**Window Replacement Project  
2737 O St Street, NW**

Owner: US Bank NA Trustee  
Contact: Noah Ganz, First Freedom Preservation  
Contact Details: 443-393-0222 ext 201 // [nganz@ffpreservation.com](mailto:nganz@ffpreservation.com)  
Lot/Square – 1260-0830  
**Case #** OG 19-075 (HPA 19-164)

**2737 O ST, NW**  
**ADDENDUM TO THE OGB PERMIT REVIEW REPORT**  
**SUBMITTED JUNE 17, 2020**

**Questions from Mary Catherine Bogard:**

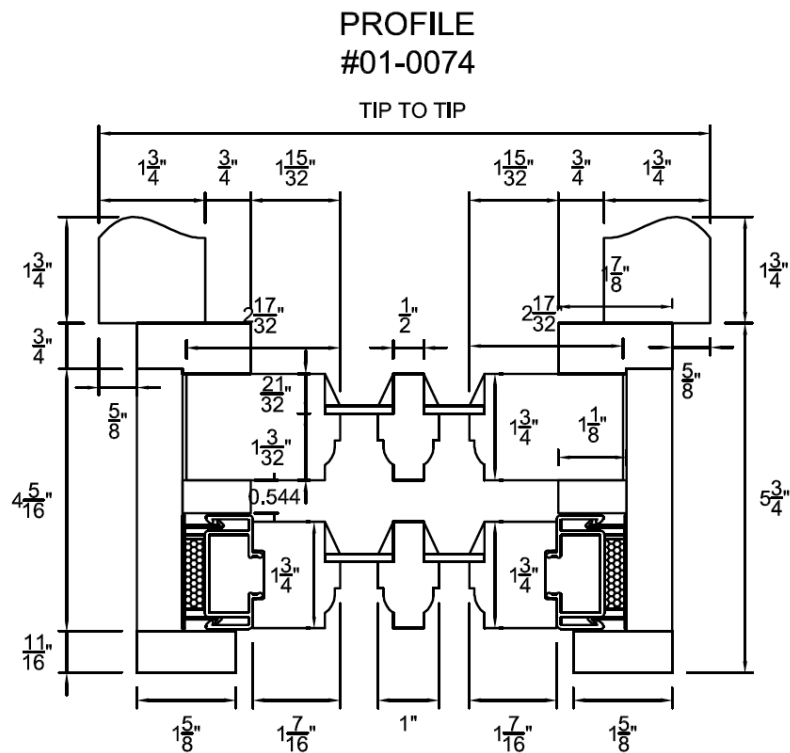
**2 - Are you proposing scroll work in the wood lintel panel of the arched windows?**

While we are very capable of fabricating decorative scrolls, we are not proposing decorative scrolls in the wood panels above the arched windows for the following reasons:

1. This house has been altered greatly over the years, most likely as its use changed. It appears to have been a commercial establishment at some point and possibly was once two separate buildings. I understand that more recently it was divided into apartments. All those changes have left just about every elevation with a mixture (one could say a hodge-podge) of (1) original window openings (arched with decorative brick headers), (2) possibly original openings (arched without decorative brick headers) and (3) added window openings that have rectangular lintels. Hence we feel that adding decorative scrolls to the arched windows would emphasize those differences when it is far more appropriate to de-emphasize them.

2. The home we have used as our most relevant model, 1250 28<sup>th</sup> St, does not employ decorative scrolls.
3. While I am not an expert on house styles, particularly when a house does not fit neatly into a single architectural type, I would best describe this home as simple Italianate. And the simplicity of 2737 O St does not lend itself to high Victorian flourishes such as decorative scrolls.

As an example, here is a similar home on Capitol Hill w/o decorative scrolls:

Current proposed Brickmould:

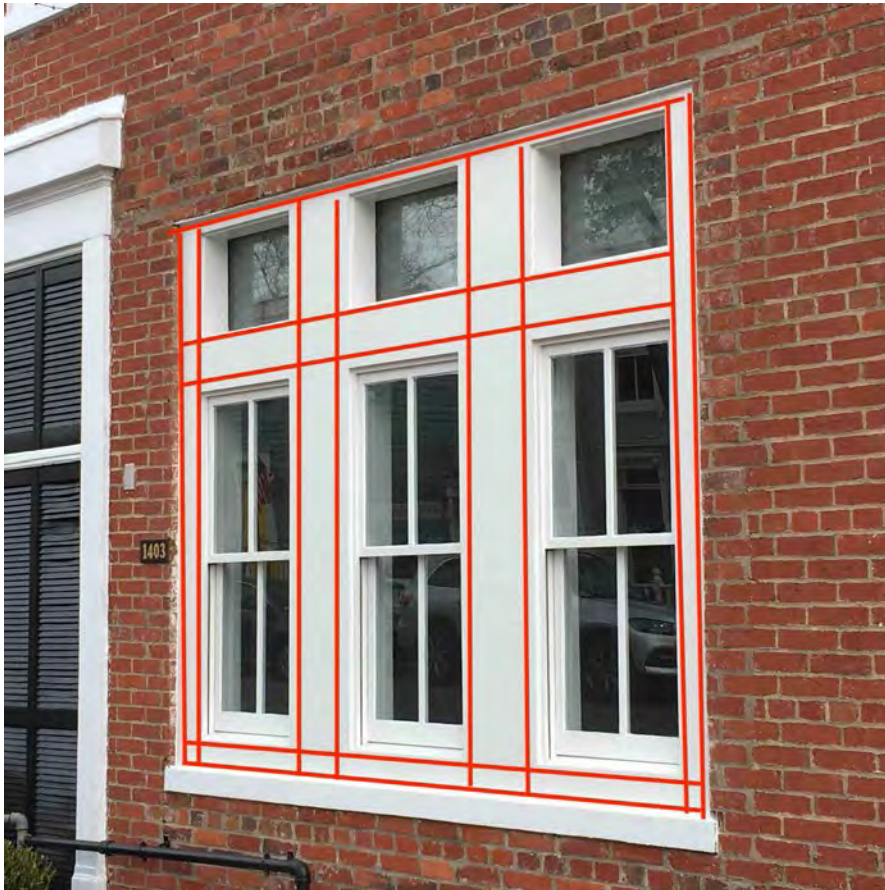
**3 - Are you proposing to duplicate the decorative bullnose profile from 1250 28th Street NW at 2737 O Street NW?**

While we are totally open to duplicating the bullnose profile found at 1250 28<sup>th</sup> St, we have drawn our windows using a similar brickmould style that we replicated for 1213 29<sup>th</sup> St. This style is found all over Georgetown in homes and commercial buildings from the late 19<sup>th</sup> century. But, we are fine replicating the brickmould at 1250 28<sup>th</sup> St if the board prefers.

2737 O ST, NW - TRIPLE WINDOW NEW CASING - OPTION 1

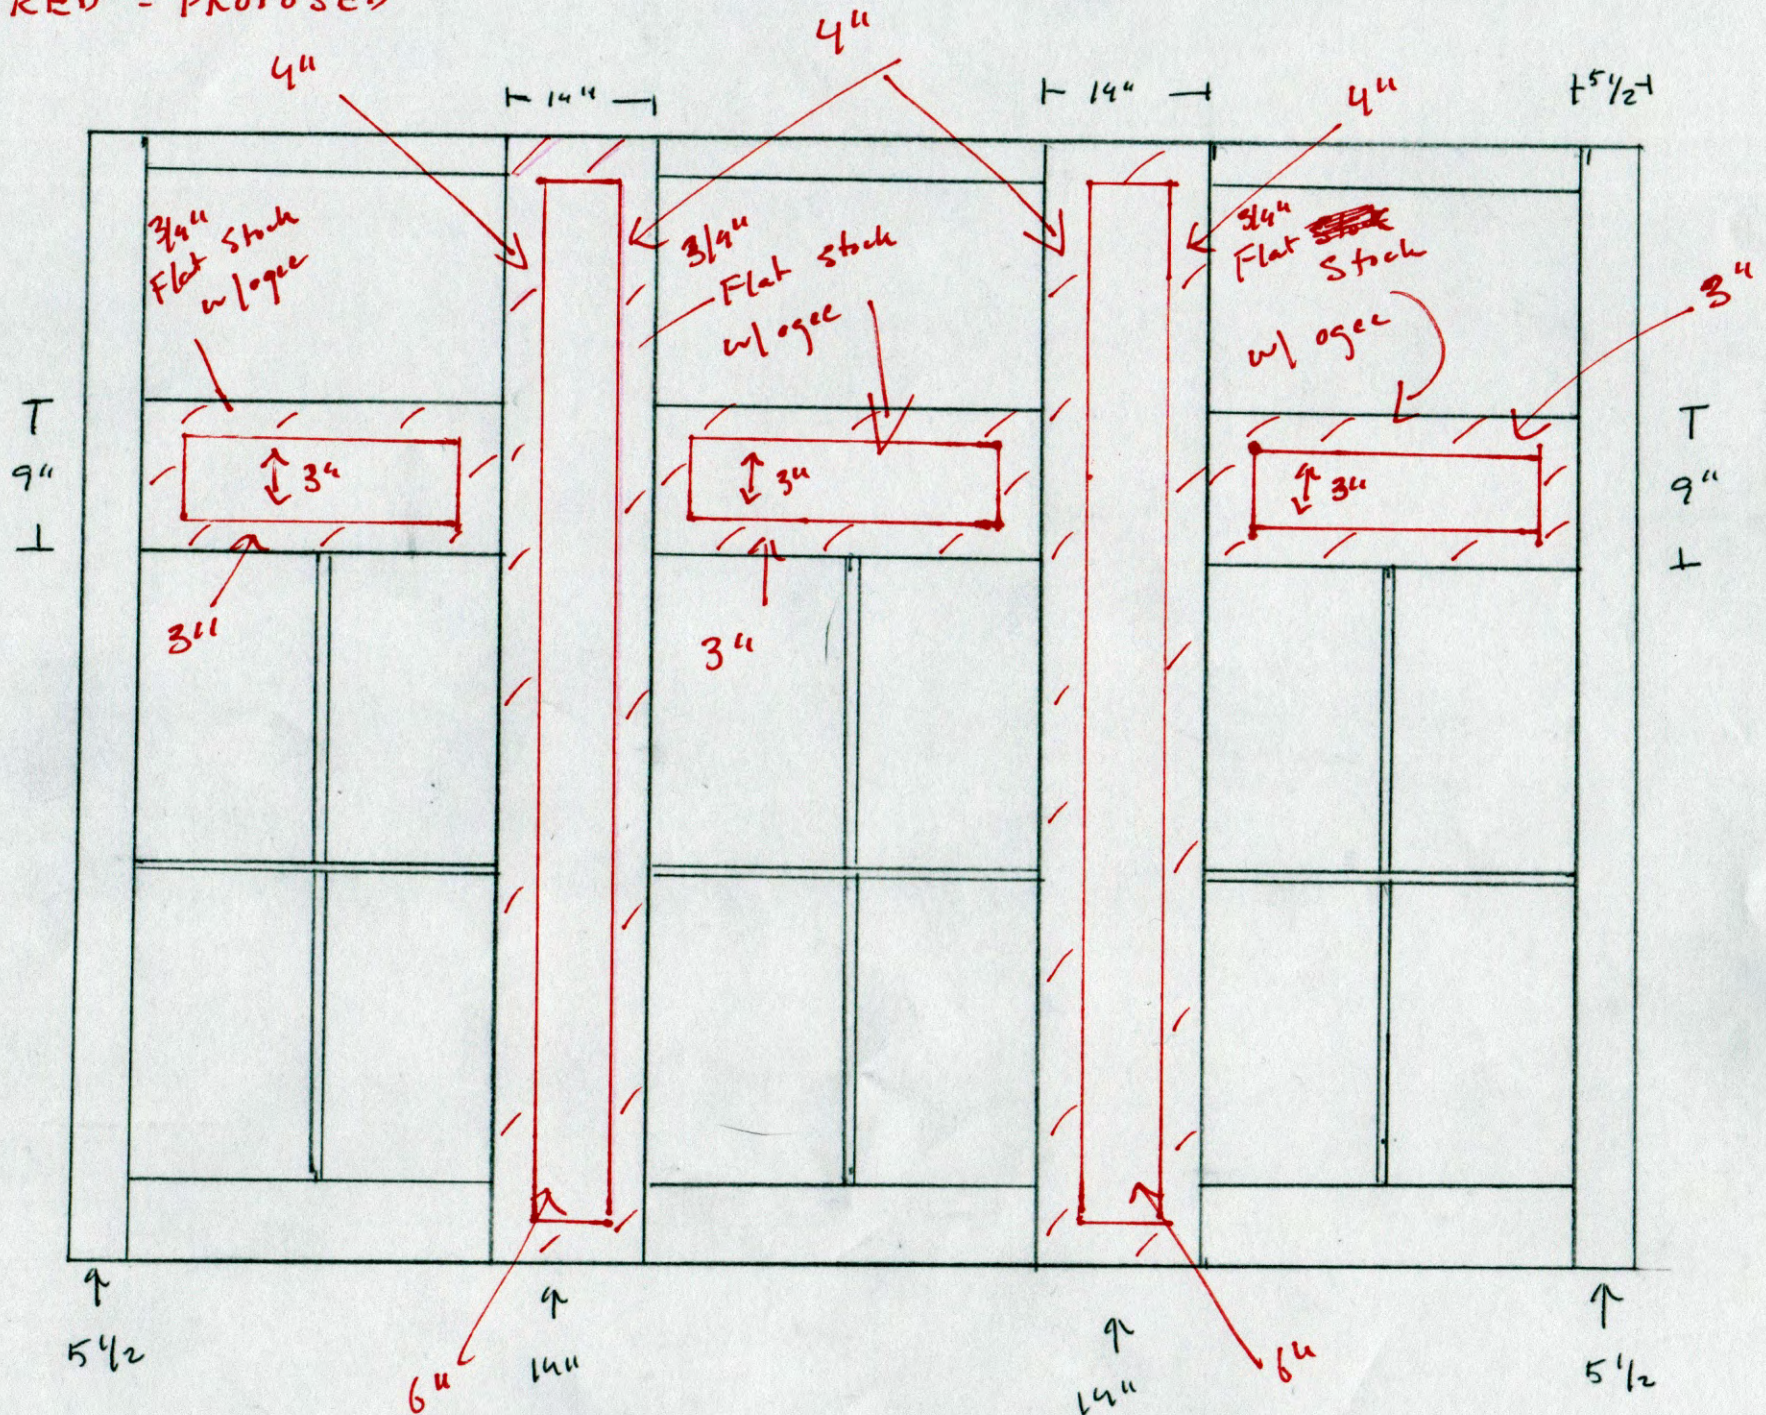
**4 - For the tripartite window, would the new pilaster-like element extend from sill to lintel of the transom? Or did you envision it stopping at the top of the double-hung window?**

We are planning to employ the pilaster-like element within the entire masonry opening.

See below:
